I found these books to be very helpful for specific problems and troubles as found and documented by the TV manufacturers themselves during the 50's. I decided they would be helpful to others in the hobby of fixing up and obsessing over old TV's like myself. Please let me know if you see any issues with the scans or need clarification on something that is not clear/visible in a scan.

*This is a series of volumes which deal with specific TV receiver troubles and their cures. These trouble cures are the TV manufacturers' answers to some of the problems that may arise in their particular receivers.*

Fig. 1 — Sparton

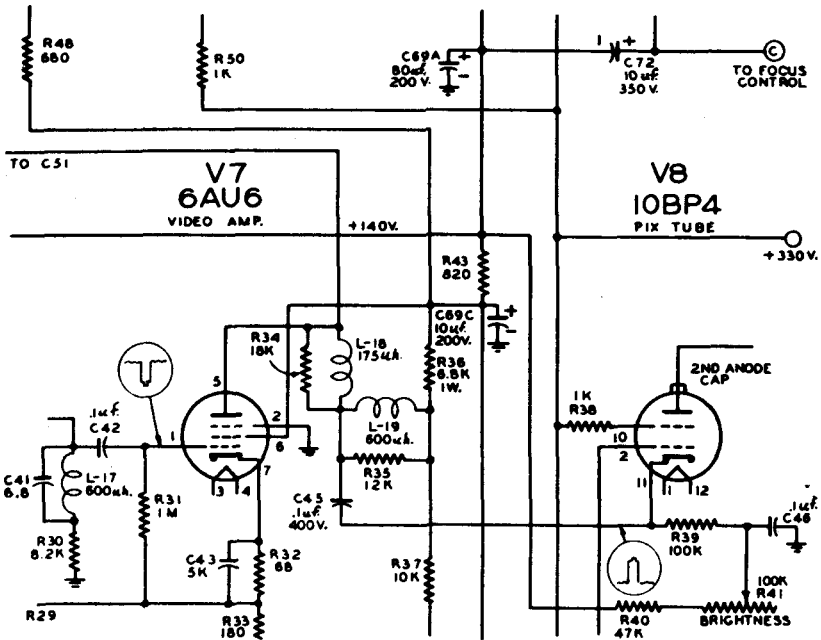
**Reducing hum in final audio stage (see Fig. 1).**

To reduce objectionable hum introduced in the final audio stage through common coupling with the video amplifier, sync separator, and sync amplifier, a decoupling network has been devised in the +140 volt line feeding these points. A sectional schematic diagram of the video i-f circuit, showing *V7*, 6AU6 video amplifier, and its associated

R48. When this change is made, the 4-point terminal strip on the receiver chassis should be replaced with a 5-point strip to provide the additional tie point needed. C69C, the 10- $\mu$ f, 200-v capacitor, is an additional section in the original C69A and C69B filter.

To effect the change follow this procedure:

1. Disconnect and remove the 4-point terminal strip already in the set.
2. Add the new 5-point terminal strip, part No. PB40200-36.
3. Add R43 (820 ohms,  $\frac{1}{2}$  w), part No. BR12S-821.
4. Disconnect and remove the old C69 filter (two section).
5. Add a new C69 filter (three section), part No. PA4307-15.

Fig. 3 - Sparton

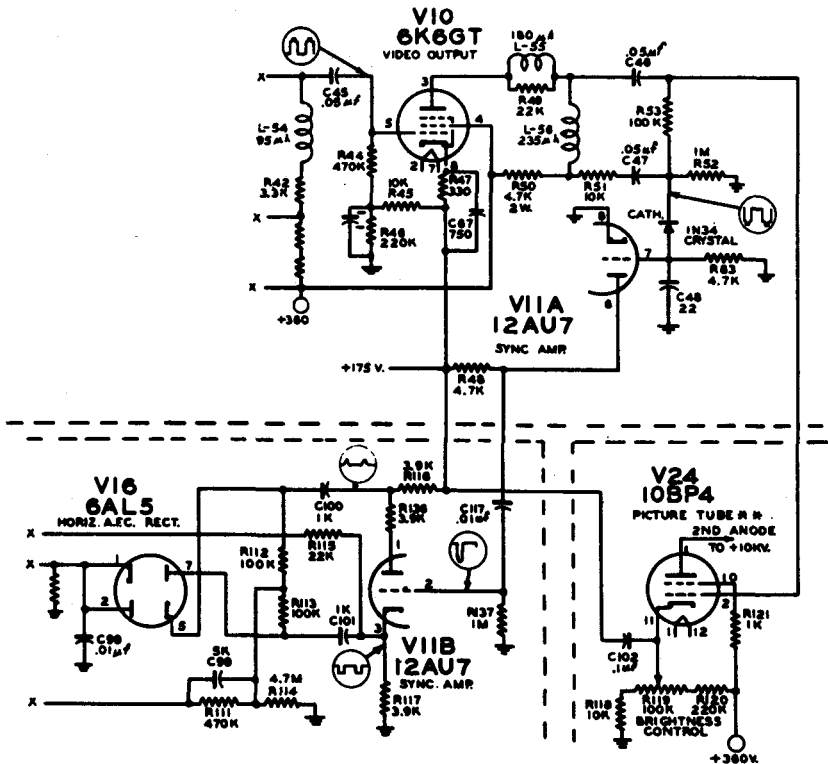
Additional sync amplification and improved receiver performance can be provided for all models using the above chassis by following the step-by-step procedure outlined below. The sectional schematic diagram shown incorporates all circuit changes. These modifications can be affected in approximately 15 minutes after the chassis has been placed on the service bench.

1. Disconnect  $R53$  (100 k),  $R52$  (1 meg), and  $C47$  (.05  $\mu\text{f}$ ) from pin 8.
2. Connect the 1N34 crystal diode (cathode end) to  $R52$ ,  $R53$ , and  $C47$ .
3. Move ground from pin 7 to pin 8.
4. Move  $C48$  (22  $\mu\text{f}$ ) from pin 6 to pin 7.
5. Remove  $R54$  (47 k) from pin 6.
6. Use new  $R83$  (4.7 k) from pin 7 to ground.

8. Replace  $R48$  (1 meg) from pin 6 to +135 volt line with new  $R48$  (4.7 k).

New parts required:

1. 1N34 germanium crystal diode (part No. PA4206).
2. 4.7-k, 1/2-watt resistor (part No. BR12S-472).

Fig. 4 — Stewart-Warner

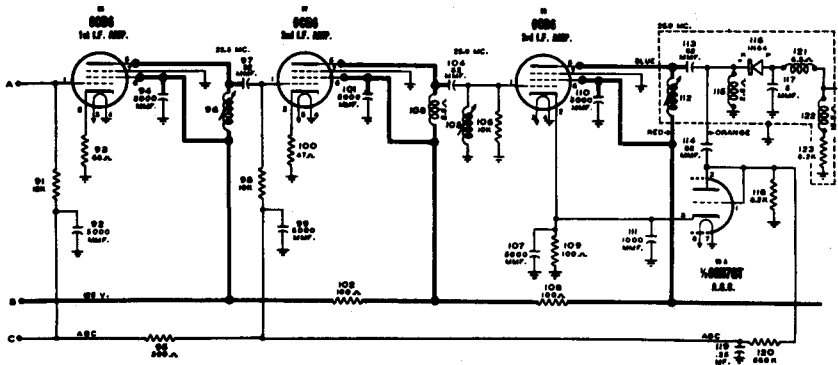
It is possible to improve sensitivity and sync stability on the above receivers by incorporating the changes listed below. Model 9202 receivers coded "Series E" and model 9203 receivers coded "Series C" already contain this modification. The circuit diagram of Fig. 4 includes these changes:

1. Replace all 6AU6 i-f amplifier tubes with 6CB6 tubes.

2. Connect socket pin 7 to ground for each of the three i-f tubes. (This is the suppressor pin on the 6CB6 tube.)

3. Remove 2.2- $\mu\text{f}$  capacitor *C239* from grid circuit of 1st i-f stage.

4. Change 1st i-f grid resistor *R91* from 8,200 ohms to 12,000 ohms.

5. Change 1st i-f cathode resistor *R93* from 47 ohms to 68 ohms; connect it from pin 2 to ground.

6. Change 2nd i-f grid resistor *R98* from 8,200 ohms to 10,000 ohms.

7. Change 2nd i-f cathode resistor *R100* from 82 ohms to 47 ohms. Connect it from pin 2 to ground.

8. Change 3rd i-f grid resistor *R106* from 12,000 ohms to 10,000 ohms.

9. Change agc load resistor *R118* from 47,000 ohms to 8,200 ohms.

Fig. 13 — Stromberg-Carlson

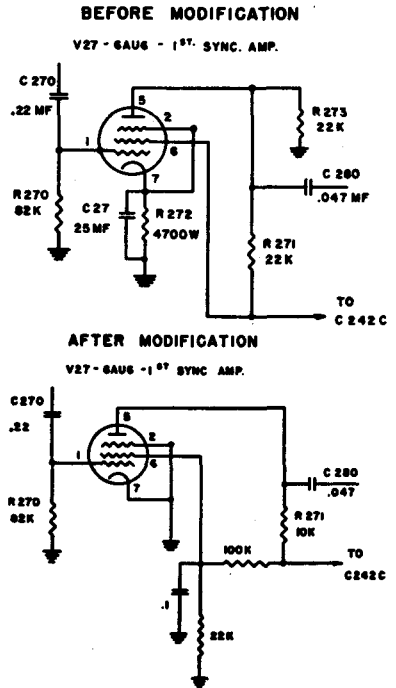
Model TC-19, 16 and 116 series  
**Replacement of pulse coils.**

Failures of the *T5* agc pulse transformer (part No. 114078) in TC-19 receivers, and the *T13* afc sawtooth coil (part No. 114090) in

16 and 116 series receivers, have been experienced when the cellulose-acetate insulation between windings breaks down under high ambient temperature and humidity conditions. Revised coil and transformer designs are used in later production with better insulation properties. Replacement units for these parts bear the same part numbers, but the revised designs are identifiable by a daub of green paint on the adjusting screw portion of these units.

Fig. 16 — Sylvania

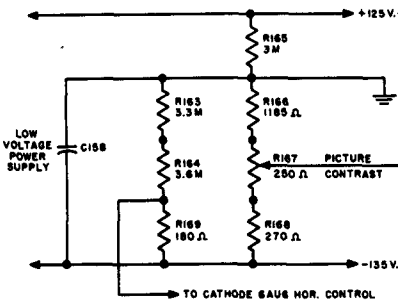
After making these changes, 4.5-mc interference may become noticeable on strong signals since co-sound rejection is not as great as with the original circuit.

The effect of this revision on the overall i-f response is shown by comparing the normal i-f overall response with the revised overall i-f response as shown in parts (B) and (C) of the figure, where *Ps* is picture marker for strong signal, *Pf* is picture marker for weak fringe signal, *Ss* is sound marker for strong signal, and *Sf* is sound marker for weak fringe signal. Part (B) shows a normal overall i-f response curve with markers for strong and fringe signals as shown when receiver is tuned for best picture. As can be seen, when a fringe signal is tuned for best picture (*Ps* moves to *Pf*), the sound carrier moves from *Ss* to *Sf* and becomes weak and separated. By making these revisions to the i-f circuit, a "kickback" is added to the sound side of the overall i-f response as shown in part (C). Now when a

fringe signal is tuned for best picture ( $P_s$  moves to  $P_f$ ), the sound is moved from  $S_s$  to  $S_f$  and is picked up by the "kickback." This provides greater amplification for the sound.

Fig. 19 — Sylvania

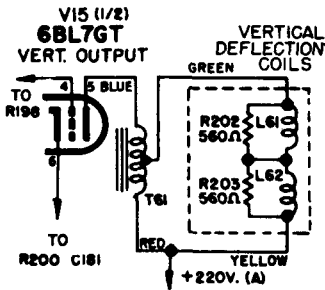
**Improved focus (see Fig. 19).**

To improve focus, the plate voltage connection of the vertical output section of *V15* is modified as shown in the figure. This change is already made in later production.

Fig. 20 — Sylvania

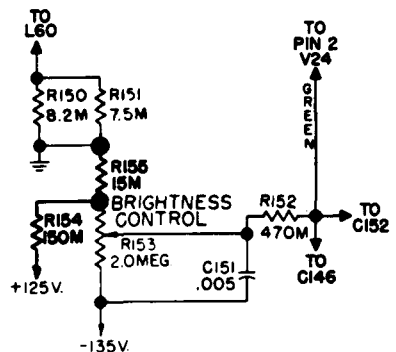
**SYLVANIA** Chassis 1-387-1, -437-3, -502-3  
**Improving operation of brightness control**  
*(see Fig. 20).*

To improve operation of the brightness control, two new resistors are added in later production. These are identified as *R154* and *R155* with values of 150,000 and 15,000 ohms respectively. See figure for connection. In some chassis, these resistors are identified as *R155* and *R156* or as *R156* and *R157*.

Fig. 22 — Sylvania

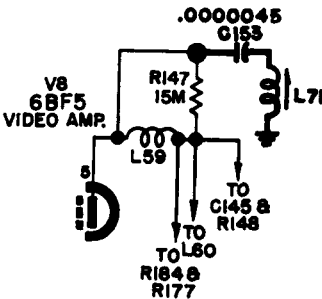
**SYLVANIA** Chassis 1-437-3  
**Reducing 4.5-mc sound interference in picture (see Fig. 22).**

To reduce 4.5-mc sound interference in picture, add *C153*, 4.7- $\mu$ f capacitor, and *L71*, 4.5-mc trap coil, in series between the plate of *V8*, 68F5 video amplifier, and ground. The alignment procedure for *L71* is as follows:

Fig. 25 — Sylvania

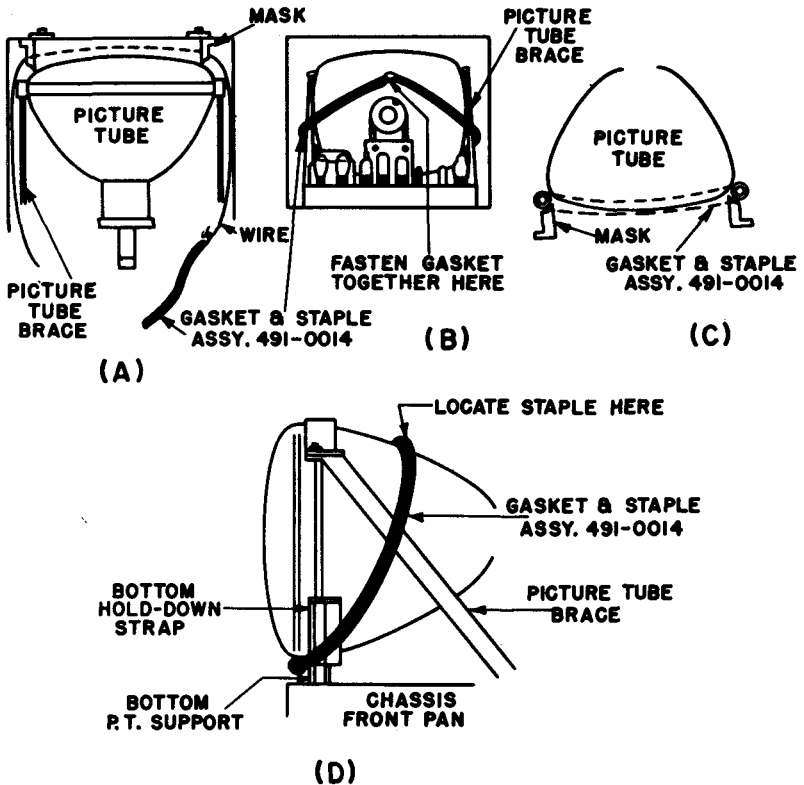
**SYLVANIA** All 17-inch chassis **Installation of dust seals for picture tube (see Fig. 25).**

Mask and gasket assembly, part No. 491-0014, may be installed on 17-inch tv models with the chassis either in or out of the cabinet. The methods for each type of installation are given as follows:

**Fig. 26 — Sylvania**

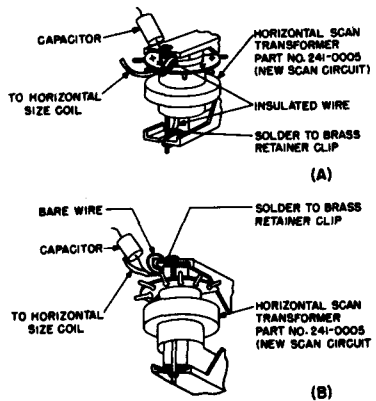
**SYLVANIA** All chassis with h-v transformer 241-0005  
**Arcing and corona in h-v transformer retaining clip**  
**(see Fig. 26).**

Arcing and corona in h-v transformer retaining clip may be corrected by connecting an insulated wire from the clip to the center transformer terminal as shown in sketch (A).

Fig. 28 — Trav-ler TV

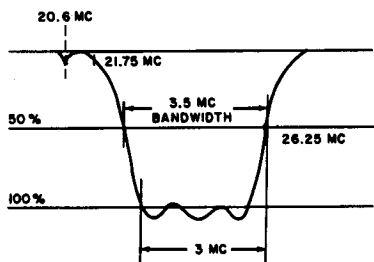
To improve tracking of picture and sound in fringe areas, later production television receivers using the above chassis have incorporated a new i-f coil TV-L-142 in the second and third i-f stages. These are L42B and L42C respectively.

The new coil is approximately 2 inches in length and mounts in the original i-f coil chassis hole. There are two separate windings on each coil form. The winding nearer the chassis is the i-f winding and contains the same number of turns as the TV-L-13 previously used. Mutually coupled and approximately 3/16-inch from the edge of the i-f winding is the audio trap winding with a 47- $\mu\mu\text{f}$  ceramic capacitor in parallel. Both windings have separate tuning slugs and are adjusted individually.

Fig. 39 — Westinghouse

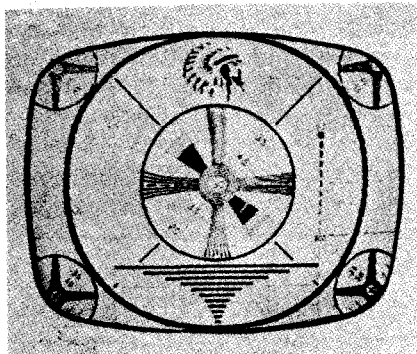
**WESTINGHOUSE** Models with 6AU5 horizontal output tube  
**Ragged picture tube pattern**  
 (see Fig. 39).

Fig. 46 — Zenith

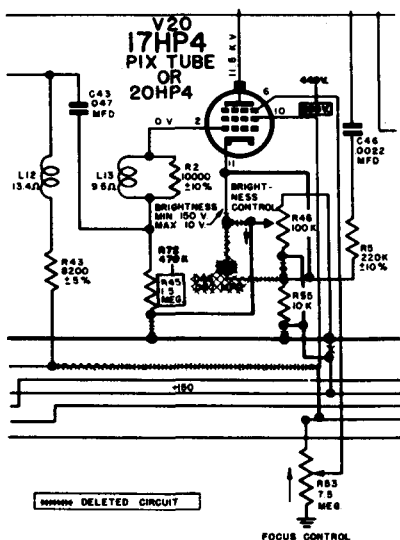
The figure shows a revised brightness control circuit with original components and voltages shown inside boxes. Circuit changes were made to accommodate picture tubes with widely varying focus characteristics. The revised circuit can be used to advantage in those receivers where focusing difficulties are experienced with replacement picture tubes of makes other than those originally supplied in the receiver.

Fig. 47 — Zenith

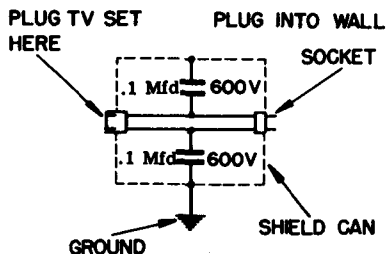
Picture interference may be caused by amateur transmitters or by police transmitters operating in the 40-mc i-f band. To remedy this condition, install a sharp cut-off,

high-pass filter between receiver antenna terminals and the transmission line. The filter ground strap should be connected directly to the turret tuner frame. A filter of this type should reject all interfering frequencies below 50 mc.
